UNITED STATES  
NUCLEAR REGULATORY COMMISSION

Subject: COOPER NUCLEAR STATION - NRC INTEGRATED INSPECTION  
REPORT 05000298/2009003

Docket: 05000298  
License: DPR-46  
Report: 05000298/2009003  
Licensee: Nebraska Public Power District  
Facility: Cooper Nuclear Station  
Location: 72676 648A Avenue  
Brownville, NE 68321  
Dates: March 25 through June 23, 2009  
Inspectors: J. Adams, Ph.D., Reactor Inspector  
M. Bloodgood, Reactor Inspector  
M. Chambers, Resident Inspector  
P. Elkmann, Senior Inspector  
R. Kopriva, Senior Reactor Inspector  
D. Reinert, Reactor Inspector  
N. Taylor, Senior Resident Inspector  
Approved By: Geoffrey B. Miller, Chief, Project Branch C  
Division of Reactor Projects

IR 05000298/2009003: 03/25/2009-06/23/2009; Cooper Nuclear Station, Integrated Resident and Regional Report; Maintenance Effectiveness, Operability Evaluations, and Other Activities.

**Figure 1: 250 V Battery Cover Cracks: Cumulative Totals**

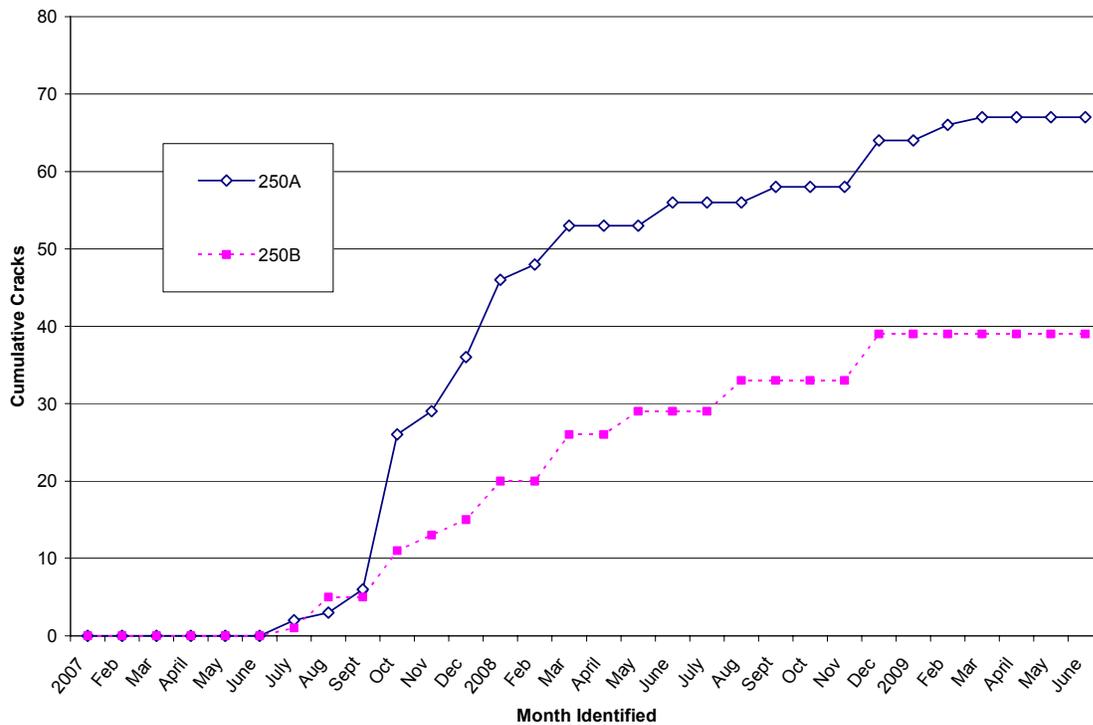
From a review of condition reports written during the previous 2 years, the inspectors determined that cell cover cracking had affected 67 cells in 250 Vdc Battery A, 38 cells in 250 Vdc Battery B, 6 cells in 125 Vdc Battery A, and 14 cells in 125 Vdc Battery B (against a total of 120 cells in each 250 Vdc battery and 60 total cells in each 125 Vdc battery). Figures 1 and 2 depict the historical trend of identified battery cell cracks.

The licensee determined that the battery cell cover cracks do not threaten the safety function of the battery. However, 250 Vdc Batteries A and B have exhibited signs of corrosion on the battery racks and grounding cables. Condition Report CR-CNS-2008-06519 identified the battery cell cover leakage as the source of this corrosion. Continued corrosion of the battery racks will likely degrade the structural strength of the battery racks and threaten their safety function. The inspectors noted that 250 Vdc Battery B is scheduled for replacement during Refueling Outage 25 and 250 Vdc Battery A during Refueling Outage 26. Additionally, the inspectors noted a degrading trend on 125 Vdc Battery B, and that no plans existed to replace this battery. Following discussion of this adverse trend with inspectors, licensee staff concurred that a degrading trend existed and will consider replacement of this battery.
